**SOLICITATION AMENDMENT  
MODIFICATION DE L'INVITATION**

<b>Title - Sujet</b> Modular Sea Containers	
<b>Solicitation No. - N° de l'invitation</b> W6399-18KB28/A	<b>Amendment No. - N° modif.</b> 001
<b>Client Reference No. - N° de référence du client</b> W6399-18KB28	<b>Date</b> 2017-11-22
<b>GETS Reference No. - N° de référence de SEAG</b> PW-\$\$HS-643-73635	
<b>File No. - N° de dossier</b> hs643.W6399-18KB28	<b>CCC No./N° CCC - FMS No./N° VME</b>
<b>Solicitation Closes - L'invitation prend fin</b> at - à 02:00 PM on - le 2017-12-13	<b>Time Zone</b> Fuseau horaire Eastern Standard Time EST
<b>F.O.B. - F.A.B.</b> <b>Plant-Usine:</b> <input type="checkbox"/> <b>Destination:</b> <input checked="" type="checkbox"/> <b>Other-Autre:</b> <input type="checkbox"/>	
<b>Address Enquiries to: - Adresser toutes questions à:</b> Chenier, Jeremy G.	<b>Buyer Id - Id de l'acheteur</b> hs643
<b>Telephone No. - N° de téléphone</b> (819) 420-0868 ( )	<b>FAX No. - N° de FAX</b> ( ) -

## AMENDMENT 001

This amendment is raised to extend the bid closing date, publish questions and answers, and modify Annex B - Operational Performance and Technical Specifications and Annex C – Technical Evaluation Pl

Figure 1: Variant I - Expandable Tricon MSC

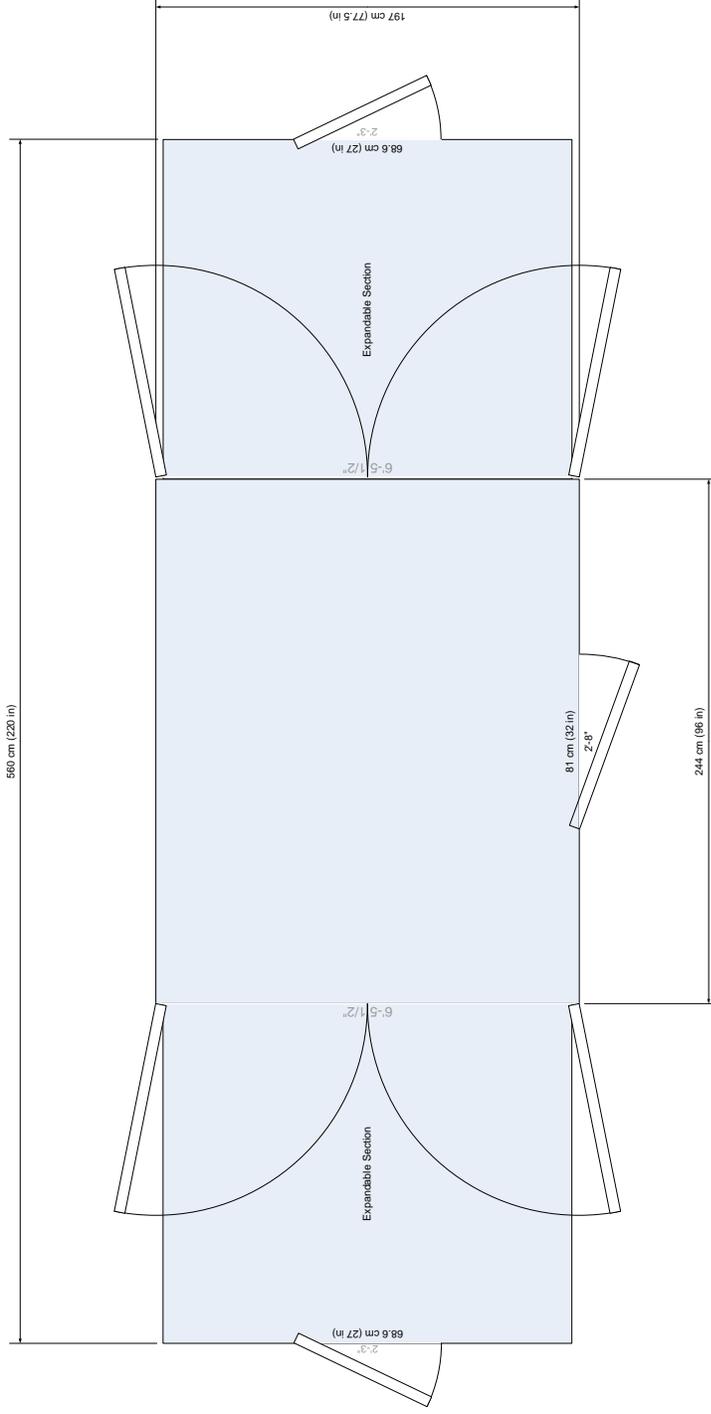
**1. In Annex B, Operation Performance & Technical Specifications for the Modular Sea Containers, Page 4 of 9, Section 3.2.2.1 (b): The internal floor area is listed as 13.3 square meters (143 square feet). Based on the external length (220 in) and external width (77.5 in) shown on the drawings, this number is not correct nor is it feasible. Please provide the correct required interior and exterior dimensions.**

**6. The expandable tricon door requirements on page 4 of 9 in Annex B call out dual outward opening doors on each side of the tricon through which the pull-out sections extend. Would an alternate design, in lieu of the dual outward-opening doors, be acceptable?**

In accordance with Annex B, Section 2.5, with the exception of the external dimensions related to ISO Series 1 freight containers, all other dimensions are stated as nominal. Any proposed design that aims to maximize the available interior space will be considered acceptable. In order to eliminate any confusion, all specified internal floor areas will be removed.

An alternate design in lieu of the dual doors would be acceptable. All other requirements remain unchanged.

Figure 2: Variant II - Expandable MSC with Cabinet

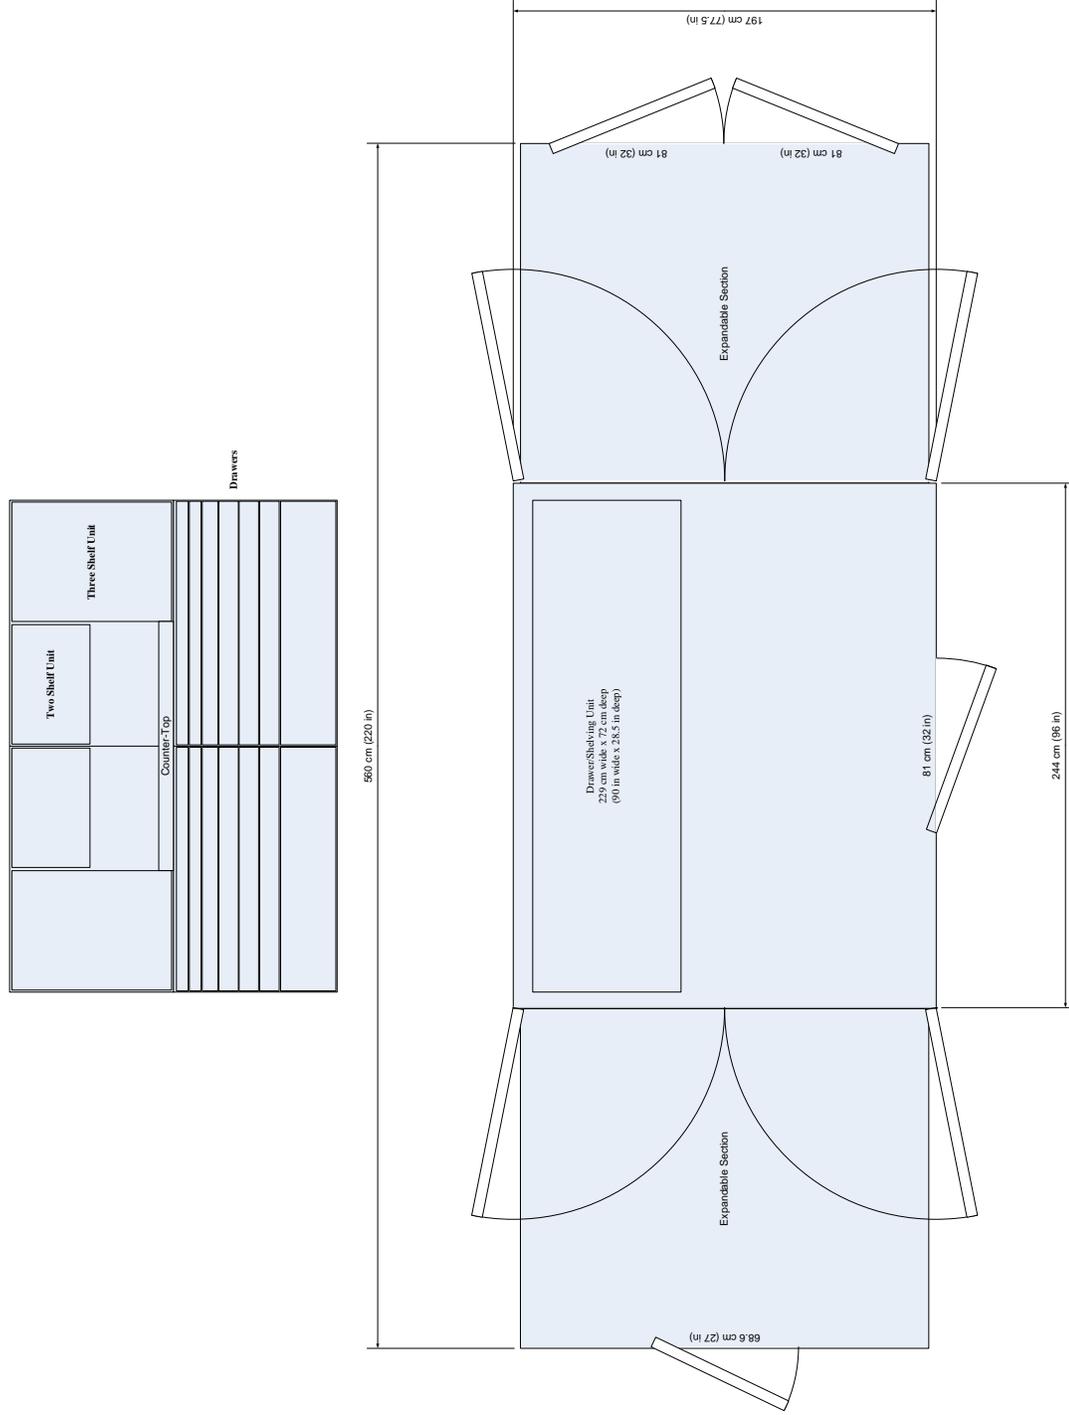
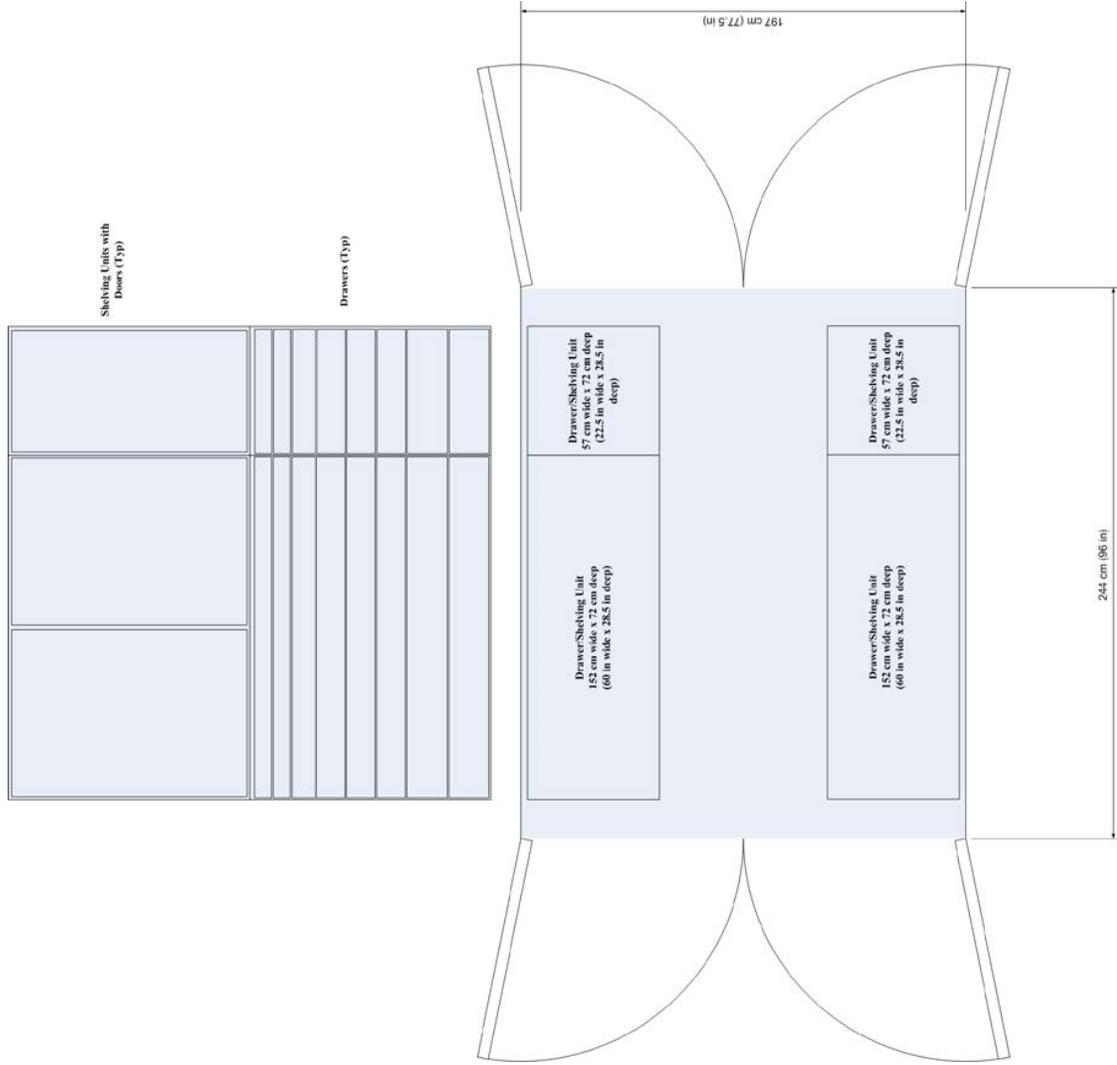
**2. For Variant II, two 45” cabinets positioned side-by-side will not fit into the internal dimensions of any known tricon design. The external total length is 96 inches, however the side doors and/or expandable walls take up space making the available internal space less than 90 inches. Should the bidder propose a cabinet design that would offer as much storage space as possible with the allowable space or will the RFP be amended to include corrected cabinet dimensions for this design?**

In accordance with Annex B, Section 2.6, the layouts should be considered as recommendations. Any proposed design that aims to maximize the available space will be considered acceptable.
